ATR on Quality Control Check Report. (Bungalows)

Quality Control Check Report. Stage: Before Casting Plinth Beam (Villas)

Description	Division	Owner & Developer	Date	Prepared by
QUALITY CONTROL PLINTH BEAM POSITION CHECK PLAN TYPE-AA2 (SBHL)	II	Modi Property Investments Pvt. Ltd. Project Name & Phase: AVRS GULMOBAR SOMES	13.11.2017	Manish
			Approved By:	Manish
			Scale:	N.T.S
				Investments Pvt. Ltd. Phone: 91-40-6635551

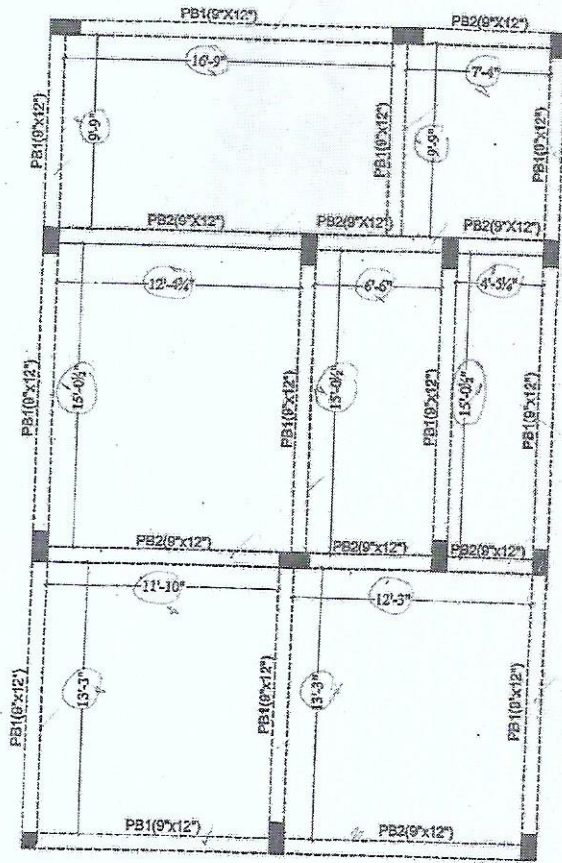
Pedestal/column - self check report attached?	<input checked="" type="checkbox"/> Yes <input type="checkbox"/> No
Remarks: (1) Mud properly not levelled. (2) Before casting P.B. mud should be removed.

Remarks:	All works completed.

Certified that all corrections mentioned in the QC report have been completed. Work can proceed to next stage.
